HARRIS

SERVICE BULLETIN

MW-1/MW-1A

AM-120-LAP
ECN 23812

RF Heatsink Assembly

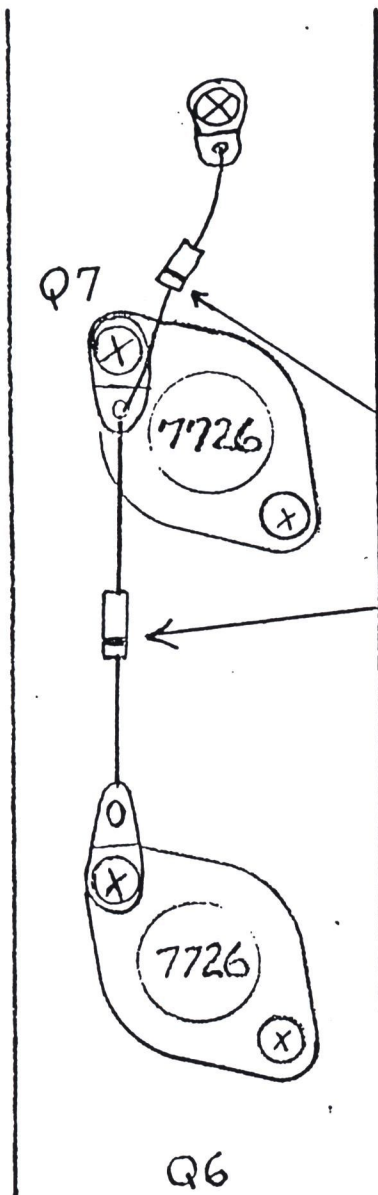
PROBLEMS ENCOUNTERED: Ringing of class 'D' waveform, random and premature loss of Q6 and Q7 in A-1 through A-13 PA module assemblies (992-4201-001), assymetrical PA voltage dip while tuning the transmitter.

The major supplier of these 2N6340 transistors (Motorola) has changed the doping mixture used to manufacture the collector-emitter junction's structure. Thus, the newly created junction characteristics may cause the operational duty cycle to be unstable.

1CR-1 and 1CR-2 (25 nanosecond reverse recovery time diodes) have been added across the emitter collector of Q6 and Q7; A-1 through A-13.

CR1, CR2 have been added as in schematic diagram

Place solder lugs under transistor mounting screws as shown in attached drawing. Cut both 1CR-1 and 1CR-2 diode leads approximately the same length. Dress leads carefully, making sure they don't come in direct contact with other components. Be sure to heat sink carefully the diode leads when soldering.

This modification is mandatory when using or replacing Motorola 2N6340 transistors manufactured, starting with 7739 and later. The date code is stamped on each transistor and is read as 7739 (77 year, 39 week). However, we recommend this improvement be made in all PA modules using transistor sockets, so that transistor life and performance may be improved when the above problems are encountered.
